May 28, 2008

Re: Responses to Comments on the 95% Design  
Herrick Hollow Creek Restoration  
Richardson Hill Landfill Site

**Comments from USEPA, USFWS and NYSDEC  
Contained in USEPA's Letter Dated April 30, 2008**

AMPHENOL CORPORATION HERRICK HOLLOW CREEK RESTORATION CONSTRUCTION DRAWING		Sheet Number	9
PLANTING AND LEVEL SPREADER DETAILS		File Number	824.006-11F
TOWN OF SIDNEY AND MASONVILLE DELAWARE COUNTY, NEW YORK

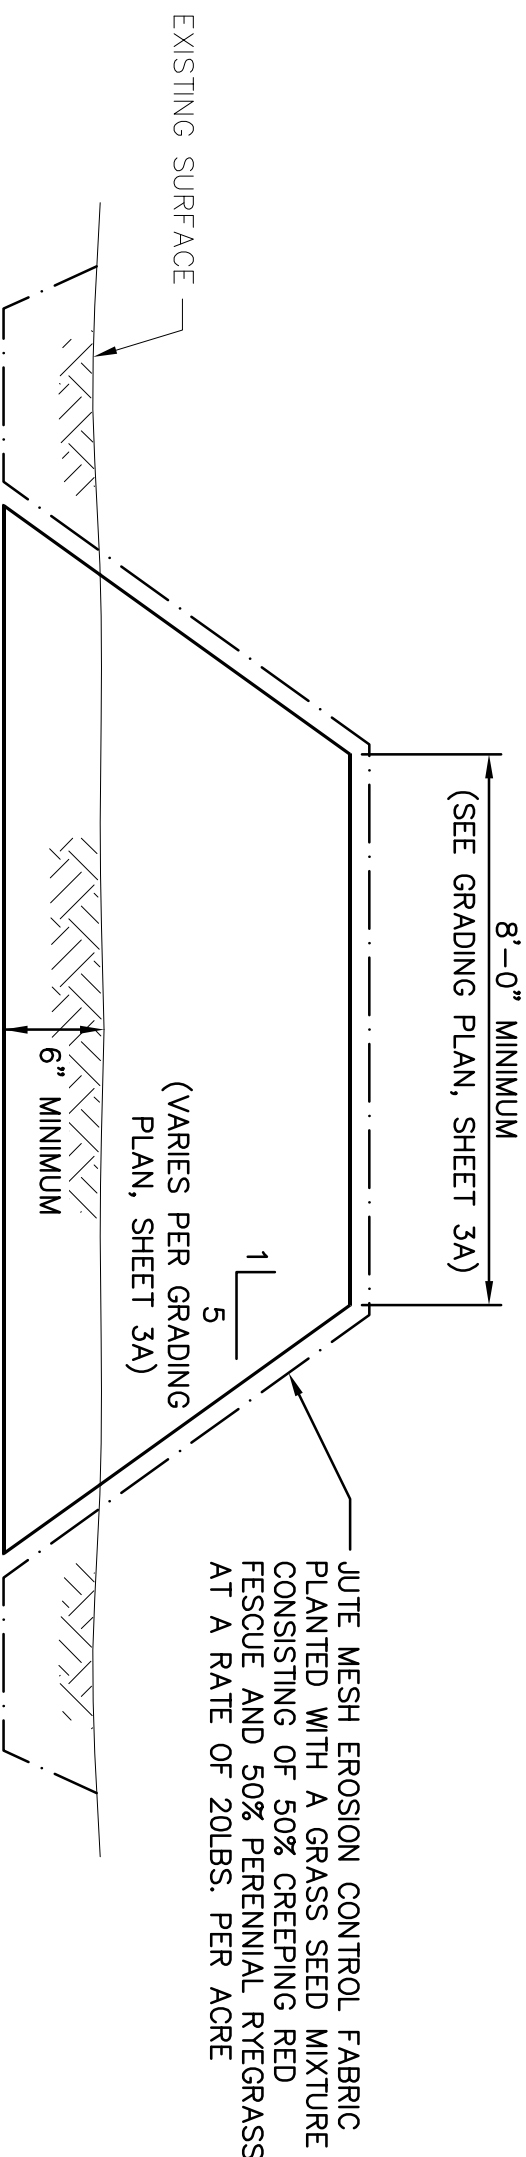
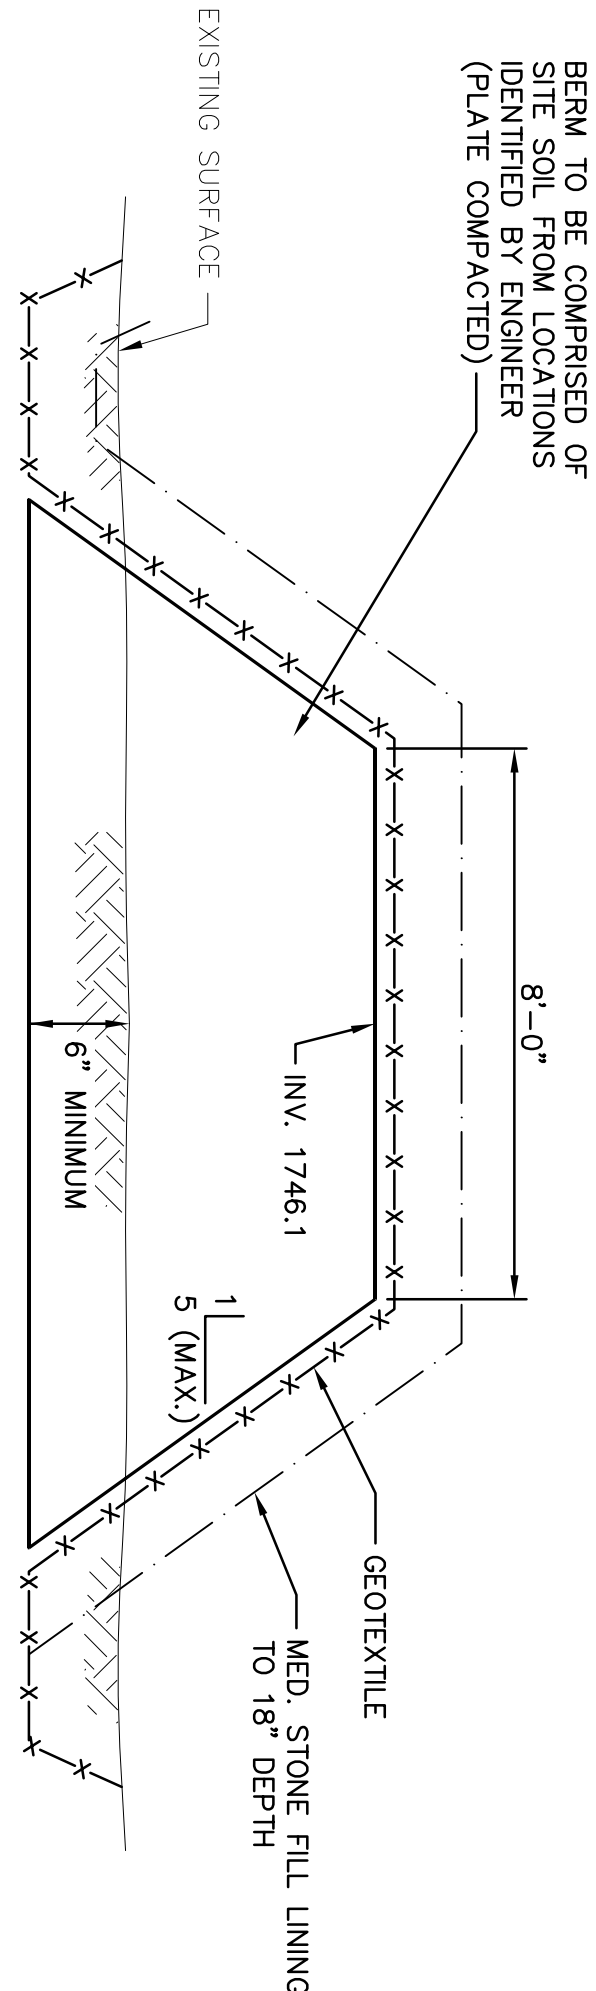
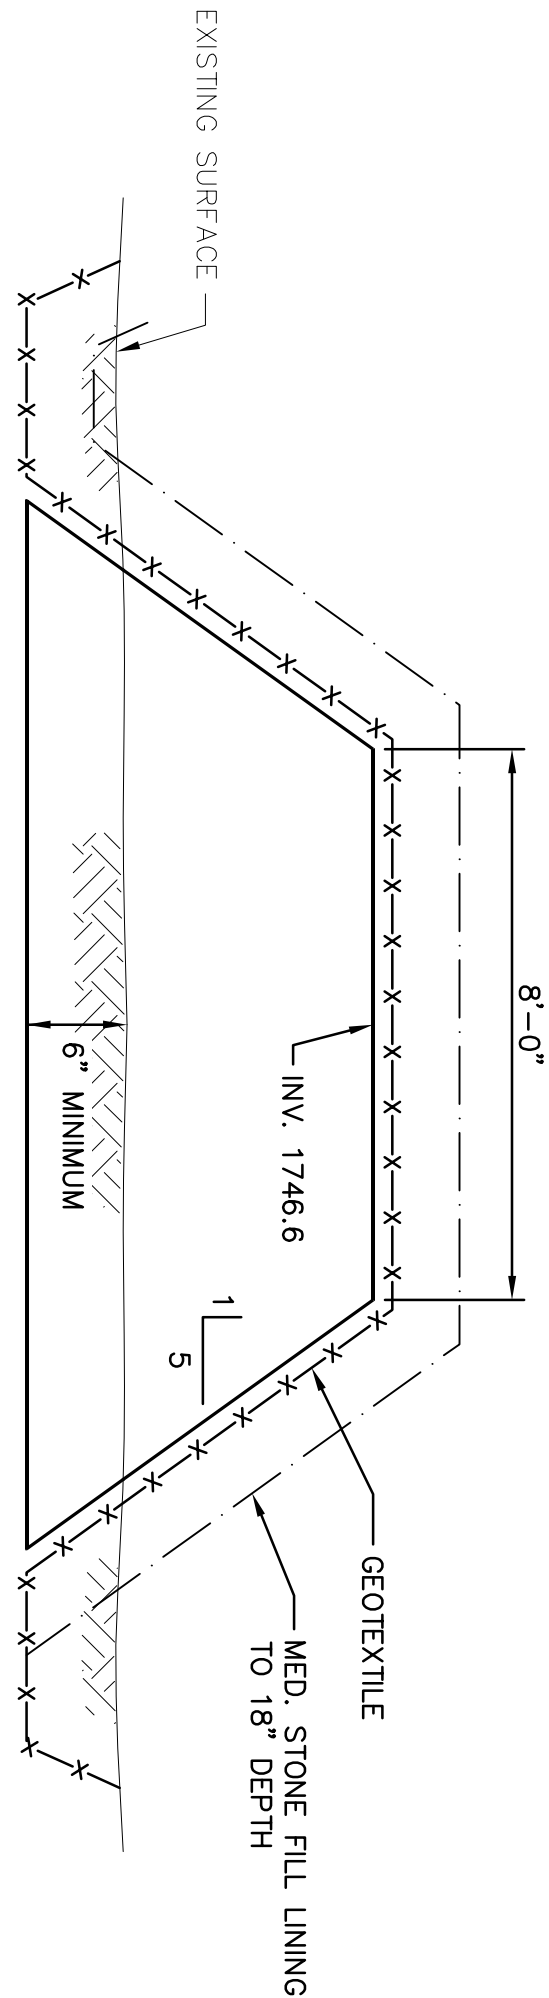
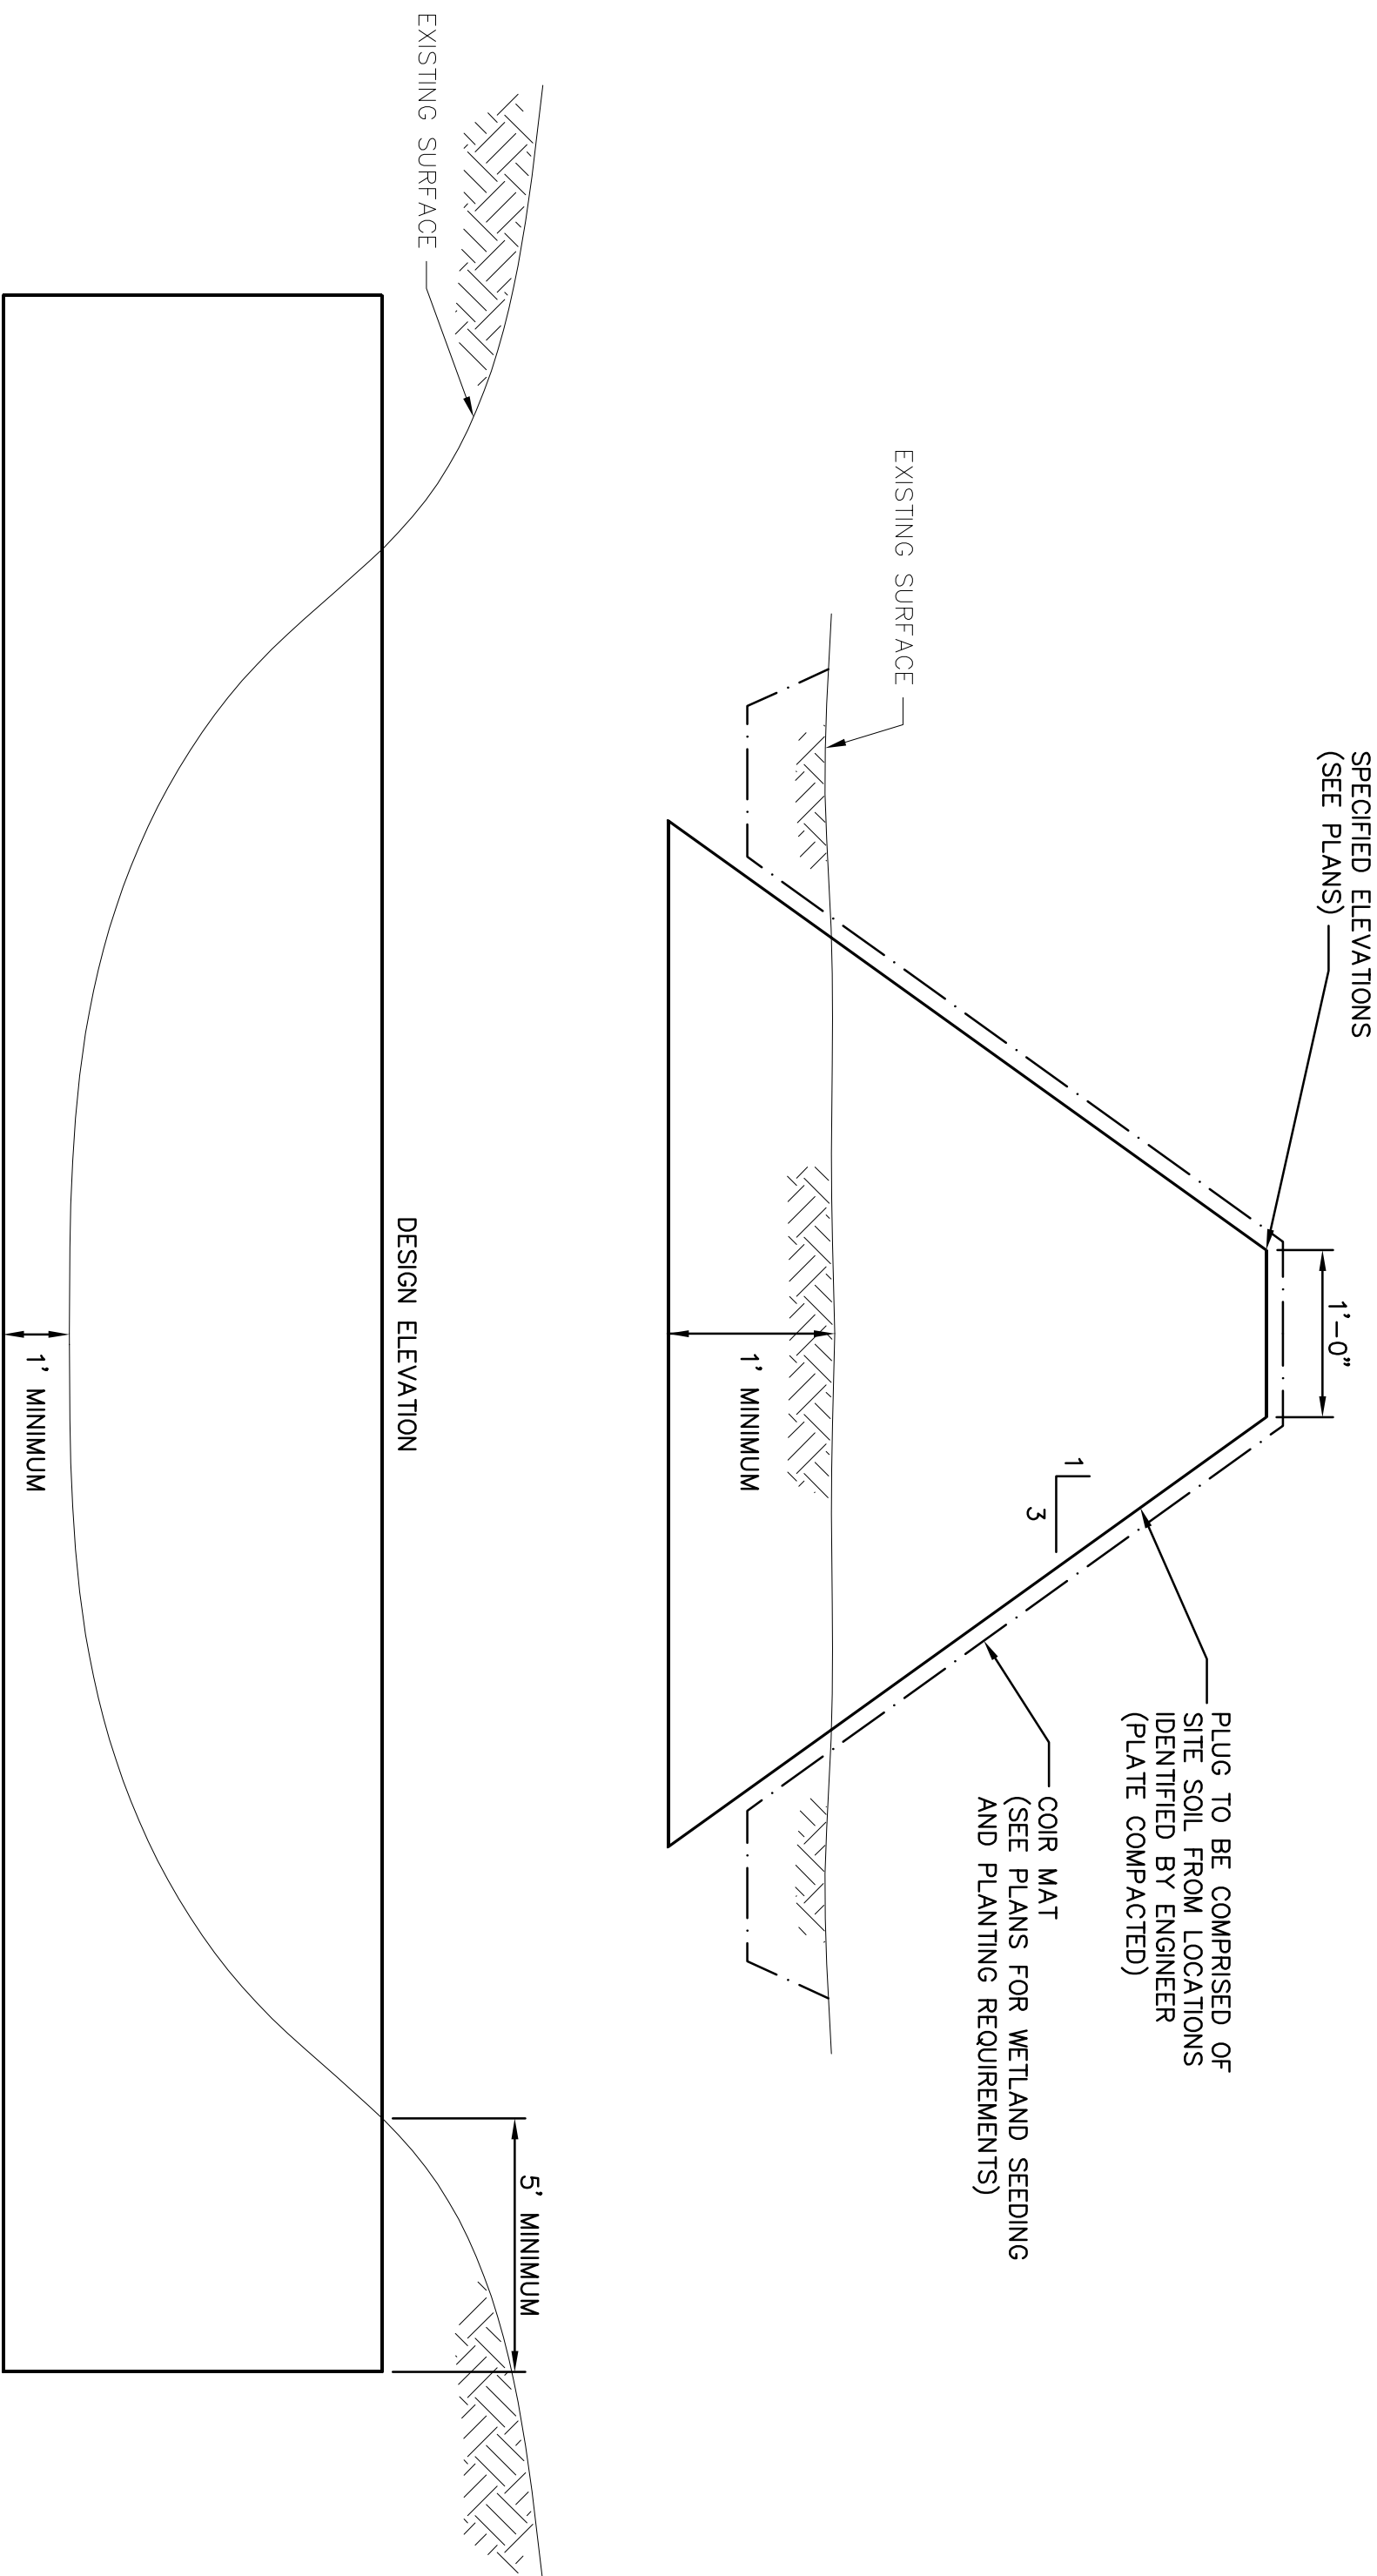
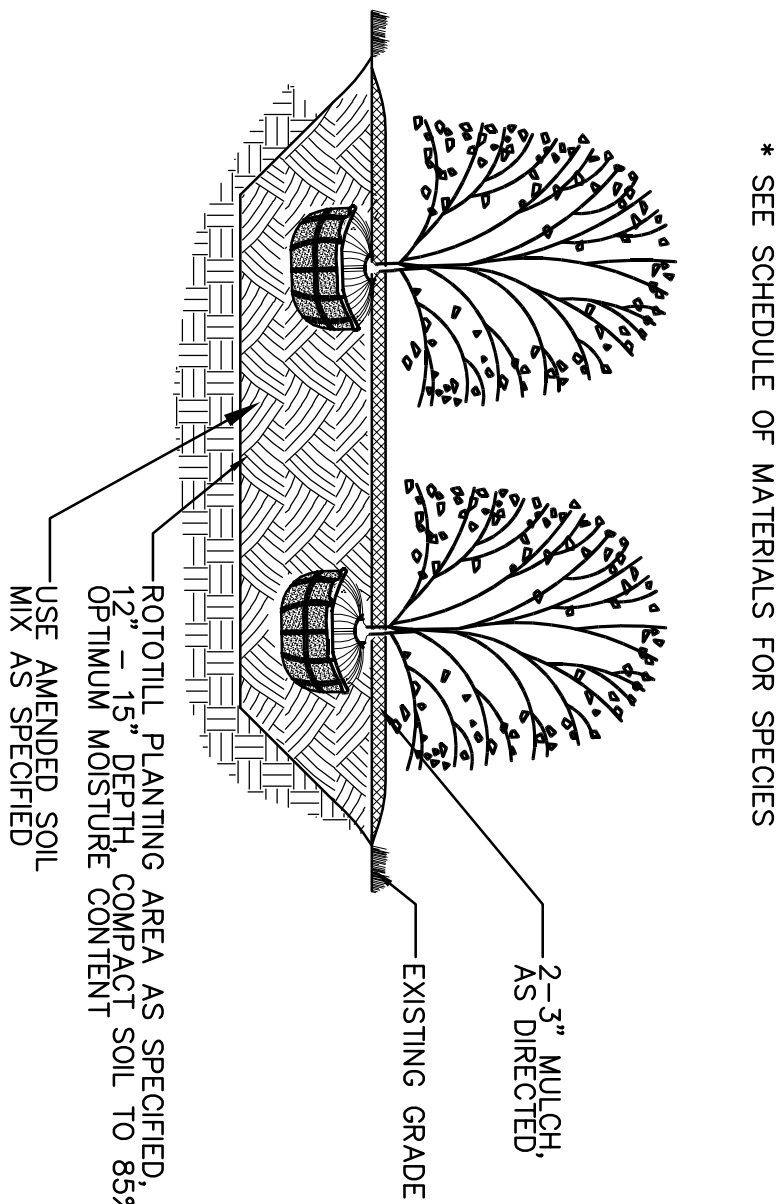
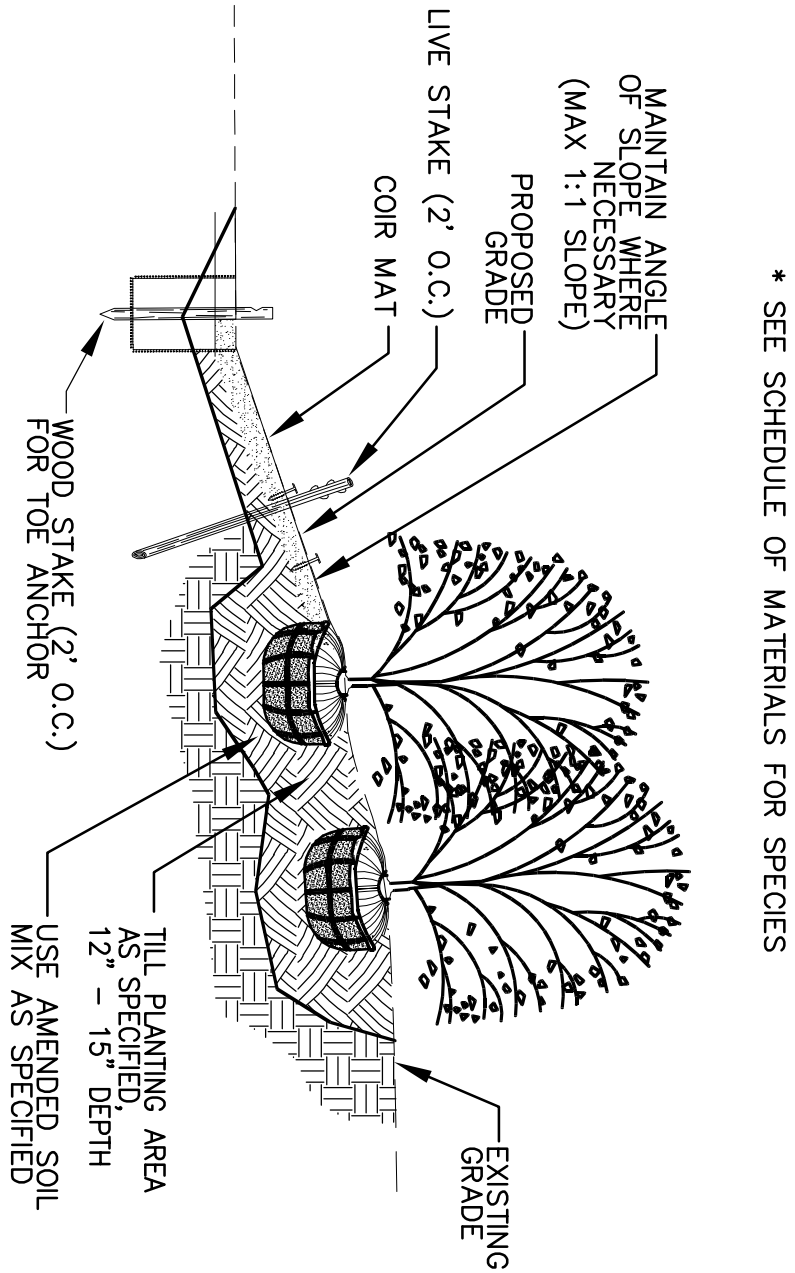
## Sheet 9

1. Level spreaders are not the appropriate structure for establishing grade control at the outlets of the wetlands to HHC as shown on sheets 2, 4 and 7. DEP suggests the use of Cross Vanes for the purpose of establishing grade control.

2. If possible use biodegradable materials to anchor geotextile or other materials instead of rebar.

3. Potted materials planted on slopes should be placed upright, not normal to the slope as shown.

*Response* – Perhaps the term level spreader is inappropriate for these structures. These are actually small dams or berms intended to regulate the water levels in the wetlands and remove the concentrated flows that have developed since the stream remediation. Here again, the intent is to back up the water and spread it out along a broad front to support the development of wet meadow hydrology along the stream bank and in other instances to develop small pooled areas for amphibian use.

*Response* – The use of rebar has been eliminated from the design drawings.

*Response* – The detail has been corrected to minimize the need for geotropism on the part of the plant.
